CABINET MEMBER FOR ENVIRONMENT – 12 JANUARY 2017

PROPOSED AMENDED TRAFFIC CALMING MEASURES HANNEY ROAD STEVENTON

Report by Interim Deputy Director of Environment & Economy (Commercial)

Client		
Project	Phase 3, Hanney Road, Steventon	Monsarch House, Barton Lane, Abingdon, Oxon, OX14 3NB Tel: 01235 959173 Fax: 01235 923226
Title	Section 278 General arrangement	Scale: 1:200@A1 Checked: [initials] Date: Feb'16 Drawing No: 5069:602 Rev: C

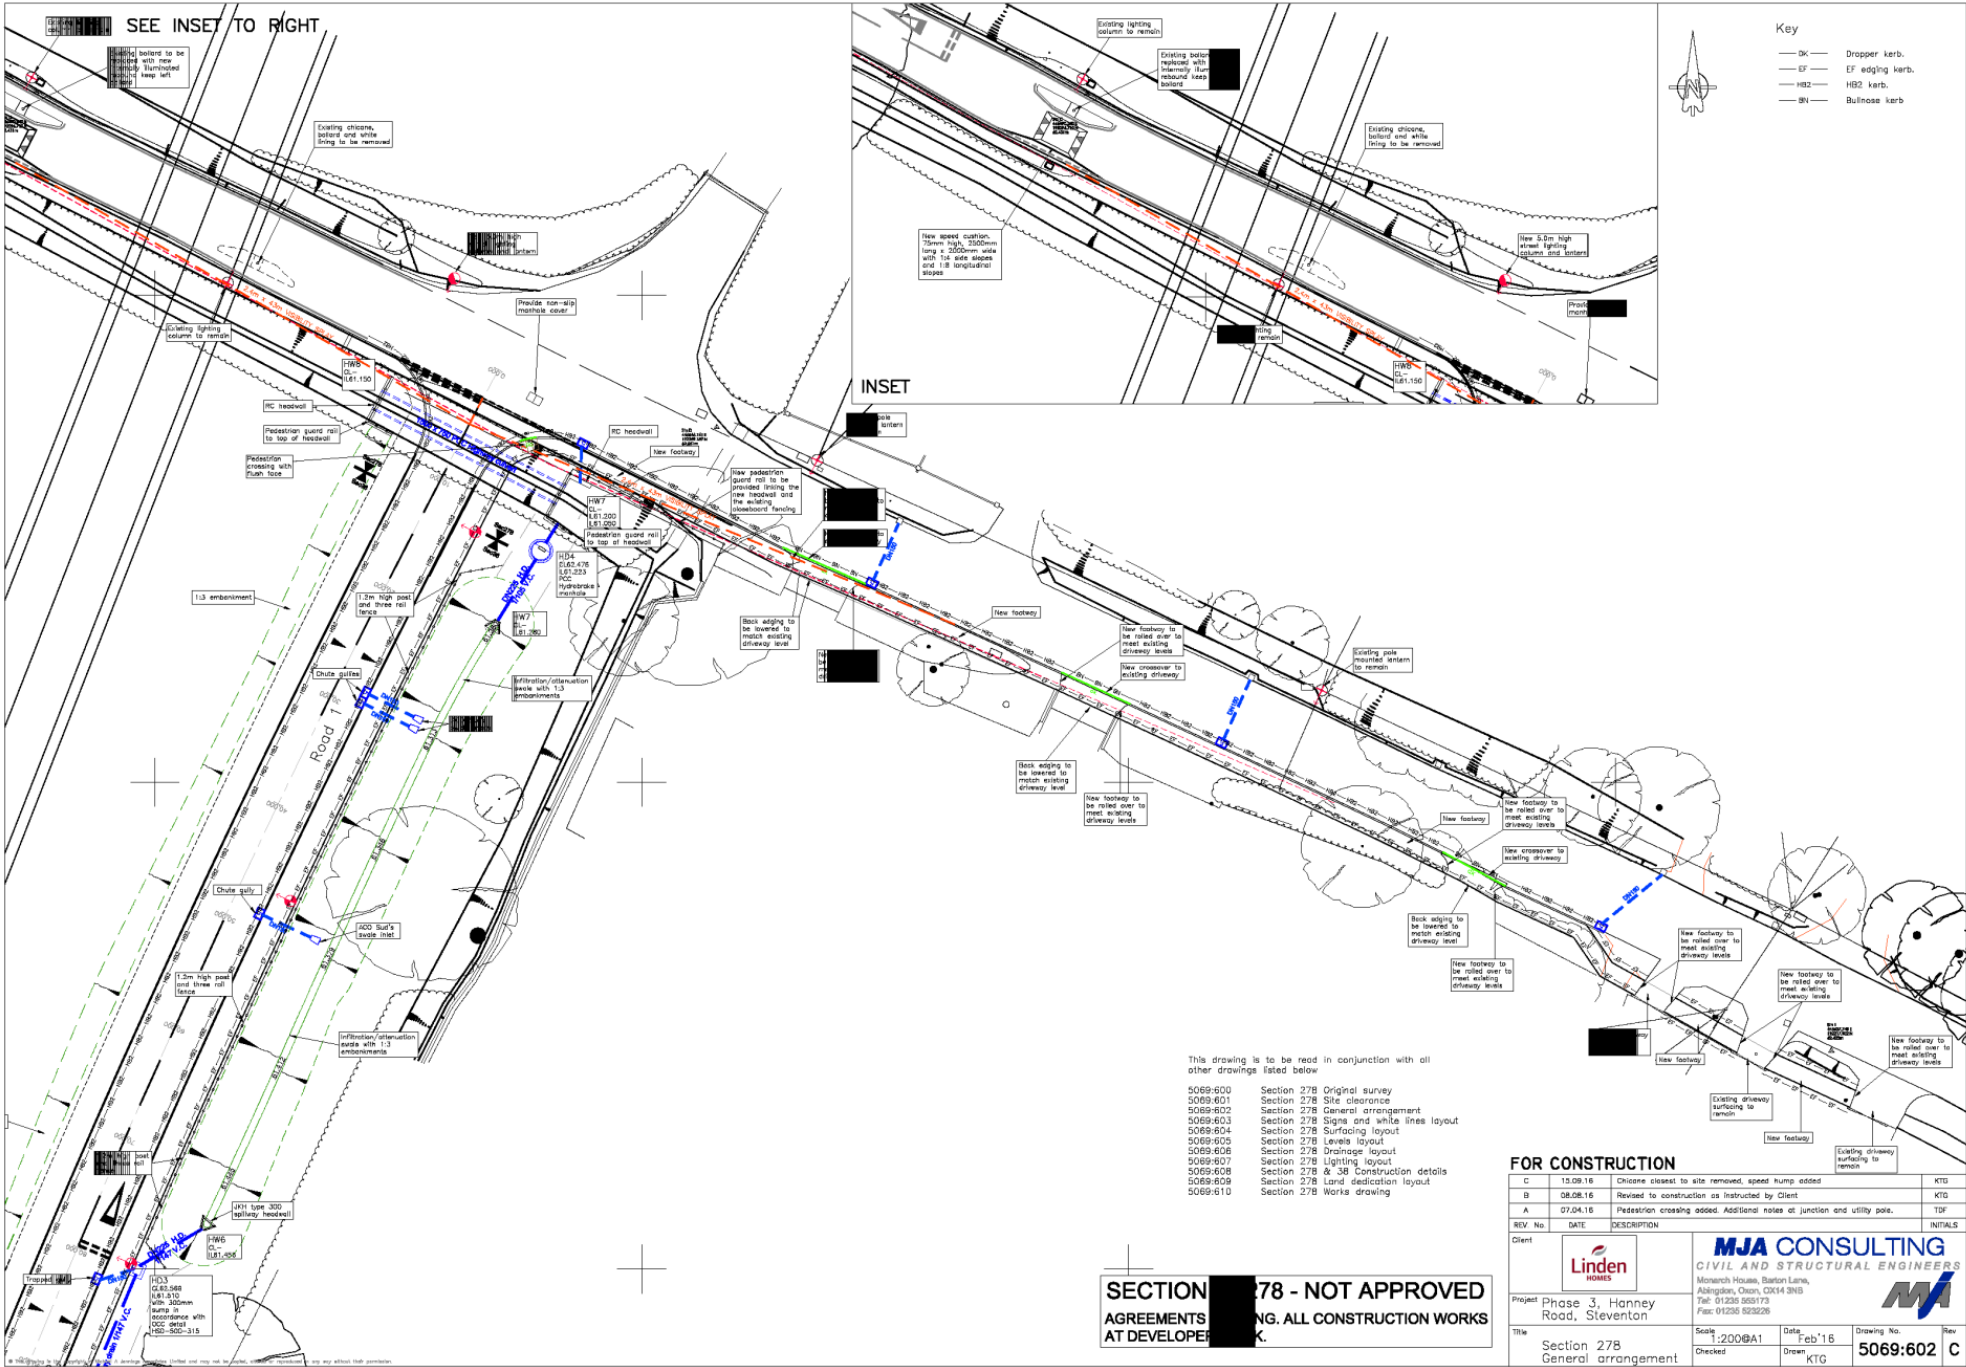
RESPONDENT	SUMMARISED COMMENTS
(1) Thames Valley Police	<p>No objection – with the following comments:</p> <ul style="list-style-type: none"> ▪ It is pleasing to see that at last some improvement is proposed for this traffic calming scheme. Over the years the existing features have suffered from serious neglect in maintenance and currently still in a poor state of repair with bollards missing and cycle by pass overgrown, ▪ The Hanney to Steventon road has for many years been an important strategic route for abnormal loads movements unable to use the A34 due to height restrictions, it is important that any amendments to the existing traffic calming features are sensitive to this fact and that any new feature is open to overrun. That will include any bollards upon the feature. No permanent fixed bollards please and any new kerbing again open to overrun by large heavy vehicles.

(2) Resident, (Hanney Road)	<p>Objects – with the following comments:</p> <ul style="list-style-type: none"> ▪ The proposed traffic calming measures make absolutely no allowance for the additional vehicles turning onto the Hanney Road and heading into the village. This is a road which vehicles already speed along, and has already had increased traffic due to the Barnet road development. I would wish to see additional traffic calming measures introduced between the proposed new speed cushion and the centre of the village aimed at reducing the existing speed problem which will only be getting worse as a consequence of the new development. ▪ The proposed traffic calming measures make no allowance for any pedestrian access from the new development into the village, as there is no curb side footpath from the new entrance into the village.

5. The response from Thames Valley Police welcomed the opportunity the proposal presented to address the removal of one of the current build outs that has been prone to maintenance issues, and raised no objection to the proposed speed cushion, on the understanding (as is the case) that the proposal would not restrict the use of the road by for use by abnormal loads unable to use the A34 due to restricted bridge clearances.

6. An objection was received from a resident of Hanney Road on the grounds that the proposed change would not be sufficient mitigation for the impact of additional traffic from the development, also taking account the current level of speeding and that further calming measures should be introduced on the Hanney Road. A concern was also expressed over the lack of provision for pedestrians wishing to walk along the Hanney Road to and from village amenities from the new access. While these concerns are noted, they are not considered material to the objective of the proposal under consideration to amend the existing traffic calming to provide a safe means of access to the development. In addition, the new development will provide a new footway on the south side of Hanney Road to link with the existing provision in the village.
